SAFETY EVALUATION BY THE OFFICE OF NUCLEAR REACTOR REGULATION

RELATED TO AMENDMENT NO. 130

TO FACILITY OPERATING LICENSE NO. DPR-61

HADDAM NECK PLANT

FIGURE 1

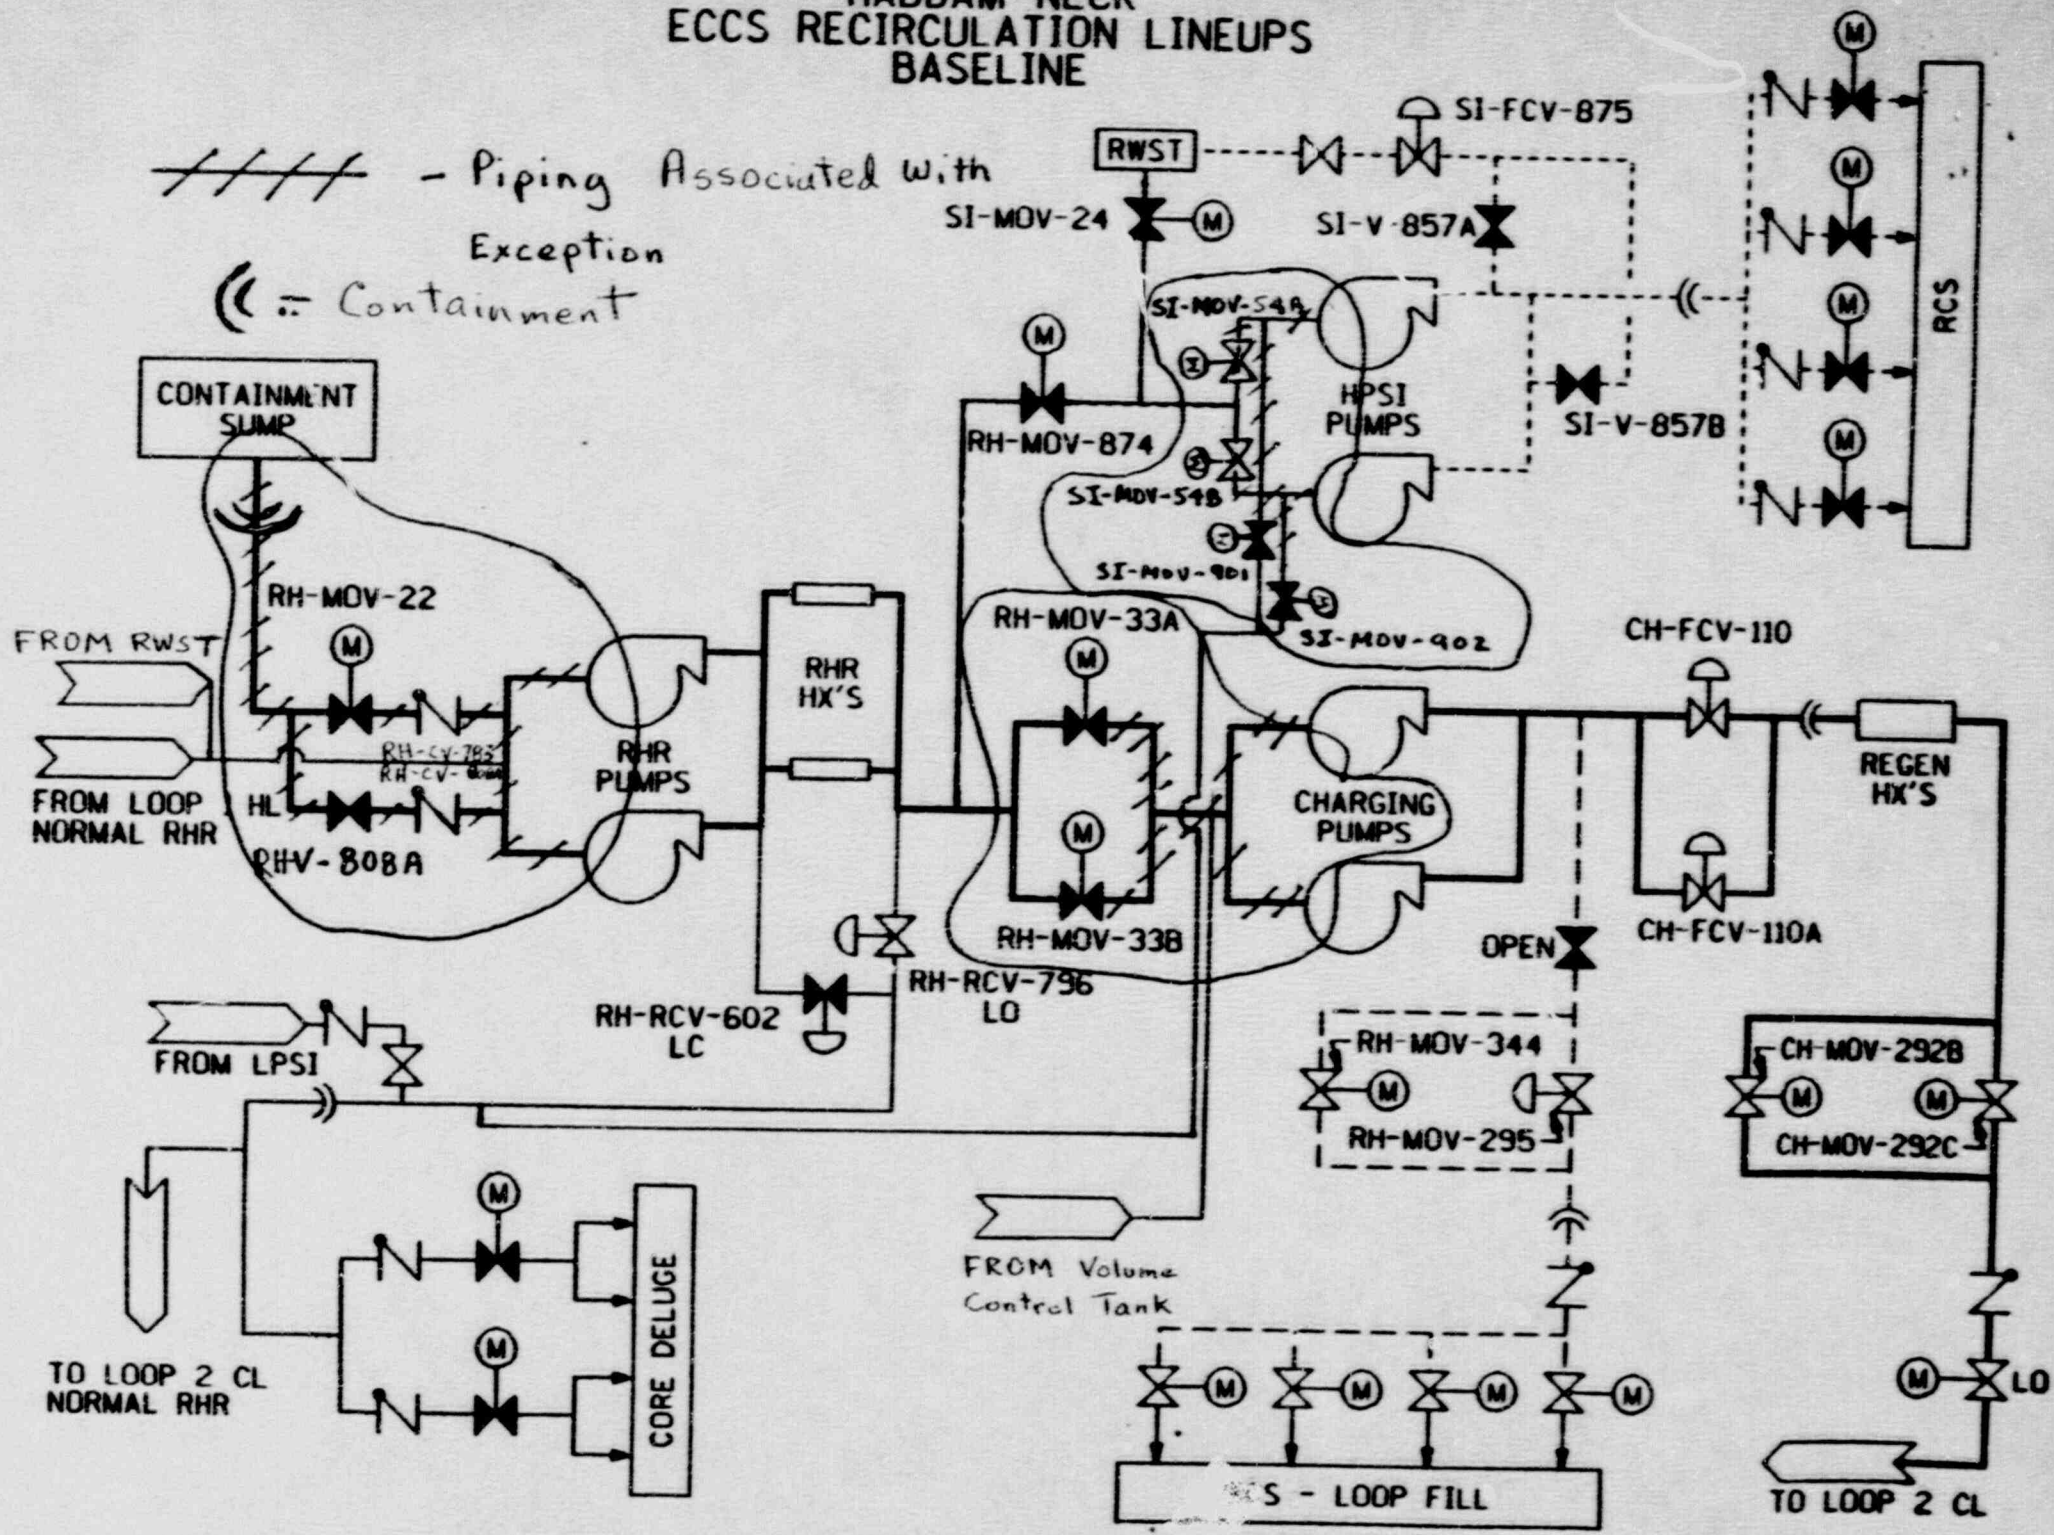
The RHR suction piping between the containment sump and the RHR pump suction (see figure 1) cannot be pressurized to accident conditions. During an accident the RHR pump suction piping would be exposed to the pressure associated with the post accident containment internal pressure (40 psig). It is not physically possible to pressurize the RHR suction piping from the sump to the sump isolation valves (RH-MOV-22 and RH-V-808A) during normal operation. The sump is open in containment and cannot be isolated to allow the piping to be pressurized. Even if it were possible to isolate the sump, performing the surveillance would disable the recirculation capability of the plant during the surveillance. To pressurize the RHR suction piping from the sump isolation valves to the RHR pumps suction would require disabling both trains of the RHR during normal operation. The RHR suction piping from the sump to the first isolation valves is always full of water and under a pressure from containment atmosphere and the hydrostatic head from the sump of approximately 6 psi. The RHR piping from the isolation valve to the RHR pump suction is also always full of water and under hydrostatic pressure from the reactor water storage tank of approximately 25 psi. CYAPCO will perform the leakage surveillance once per 31 days as required by TS 4.4.6.2.1.g at these reduced pressures and extrapolate the leak rates to the operating pressure during accident conditions.

The HPSI suction piping downstream of the HPSI suction valves (SI-MOV-854A and B) and RHR/HPSI Crossclic valves (SI-MOV-901 and 902) and upstream of the HPSI pump suction (see figure 1) during an accident are pressurized to the RHR discharge pressure (approximately 180 psig) plus the containment accident pressure (40 psig maximum). To test this piping during power operation would require aligning the HPSI suction piping to the RHR/LPSI discharge piping. The LPSI discharge design pressure is greater than the HPSI suction piping design pressure. During the test an actuation of the LPSI would damage the

HPSI suction piping. To safely perform the test the licensee believes the LPSI should be disabled to protect the HPSI system. The HPSI suction piping is always full of water and under hydrostatic pressure from the reactor water storage tank of approximately 25 psi. Surveillance 4.4.6.2.1.g will be performed as required but at this lower pressure and the licensee will extrapolate the leak rates to the operating pressure during accident conditions.

The charging suction piping downstream of the RHR/charging Crosstie valves (RH-MOV-33A and B) and the charging pump suction (see figure 1) during an accident are pressurized to the RHR discharge pressure plus the containment pressure. To test this piping during power operation would require aligning the charging suction piping to the RHR/LPSI discharge piping. To perform the surveillance the charging system would have to be isolated to prevent the injection of highly borated water into the RCS. The charging system is required during power operation for reactivity and chemistry control. The charging suction header is always full of water and under the hydrostatic pressure from the volume control tank (VCT) (approximately 10 psig) plus a 25 to 50 psig gas overpressure in the VCT. Surveillance 4.4.6.2.1.g will be performed at this reduced pressure and the licensee will extrapolate the leak rates to the operating pressure during accident conditions.

- 1) Containment sump to first isolation valve will be tested during the ILRT at the accident pressure. The deviation is that the ILRT is required to be performed at approximately an interval of three times every ten years.
- 2) From RH-MOV-22 to RH-CV-783 and RH-V-808A to RH-CV-808A the piping will be tested at approximately 6 psi and the leakage will be extrapolated to the pressure under accident conditions.

- 3) From RH-CV-783 and RH-CV-808A to the RHR pumps suction will be tested at approximately 30 psi and the leakage will be extrapolated to the pressure under accident conditions.

Technical Specification 4.4.6.2.1.f requires that this piping be monitored for leakage at least once per 12 hours with all identified leakage quantified and added to the monthly leakage determinations. CYAPCO has proposed TS 4.4.6.2.1.i which requires that 1) during the integrated leak rate test for Appendix J, when the containment is pressurized to 40 psig, the plant will perform a leakage check of the RHR suction piping from the containment sump to the first isolation valves (RH-MOV-783 and RH-V-808A), 2) from the first isolation valves to the first check valves (RH-CV-783 and 808A) the piping will be tested at approximately 6 psi and the leakage extrapolated to the operating pressure under accident conditions, and 3) from the check valves (RH-CV-783 and 808A) to the RHR pumps suction the piping will be tested at approximately 30 psi and the leakage extrapolated to operating pressure under accident conditions. The RHR suction piping from the isolation valves to the RHR pumps will be hydrostatic tested in accordance with Specification 4.0.5, "Inservice Inspection." Based on the above the staff has concluded that CYAPCO has taken appropriate compensatory measures and that the testing for RHR suction piping leakage at accident pressure every 31 days would provide little or no additional assurance of RHR system leakage. The staff concludes that the TS change is acceptable.

Technical Specification 4.4.6.2.1.f requires that this piping be monitored for leakage at least once per 12 hours with all identified leakage quantified and added to the monthly leakage determinations. In addition, the licensee has proposed a new TS surveillance 4.4.6.2.1.i which requires an operational leakage check at accident pressures every 18 months. This new surveillance will test the HPSI suction piping at RHR discharge pressure. At the time of recirculation, the containment pressure is significantly reduced and the RHR discharge pressure is a good approximation of HPSI suction piping accident pressure. The HPSI suction piping is also hydrostatic tested in accordance with Specification 4.0.5 "Inservice Inspection". Based on the above, the staff has concluded that performing the surveillance would require disabling both trains of the LPSI system during power operation and would provide little or no additional assurance of HPSI suction piping leakage. The staff has also concluded that CYAPCO has taken appropriate compensatory measures and the TS change is acceptable.

Technical Specification 4.4.6.2.1.f requires that this piping be monitored for leakage at least once per 12 hours with all identified leakage quantified and added to the monthly leakage determinations. In addition, the licensee has proposed a new TS surveillance 4.4.6.2.1.i which requires an operational leakage check at accident pressures every 18 months. This new surveillance will test the charging suction piping at RHR discharge pressure. At the time of recirculation, the containment pressure is significantly reduced and the RHR discharge pressure is a good approximation of charging suction piping accident pressure. The charging suction piping is also hydrostatic tested in accordance with Specification 4.0.5. Based on the above, the staff has concluded that the surveillance test would require disabling the charging system during power operation which would severely restrict plant operation and would provide little or no additional assurance of charging suction piping leakage. The staff has also concluded that CYAPCO has taken appropriate compensatory measures and the TS change is acceptable.
